Interpretation: 10-1

Subject: ANSI B30.10-1975

FIG. 2 EYE HOOK
(Latch — When Required)

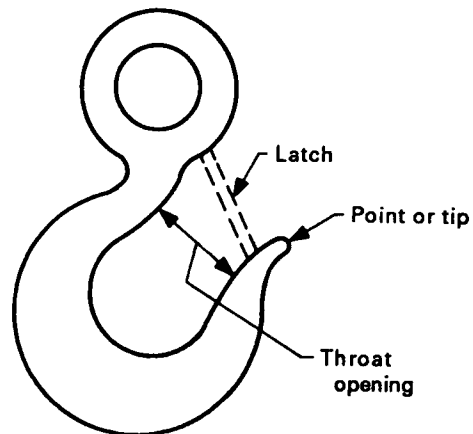
Question: Would it be correct to interpret the throat opening as the narrowest opening between the back of the hook and the tip at the entrance to the bowl as shown in Fig. 2?

Reply: Yes, your interpretation is correct for the figure cited. However, your interpretation may not be correct for other hook configurations.
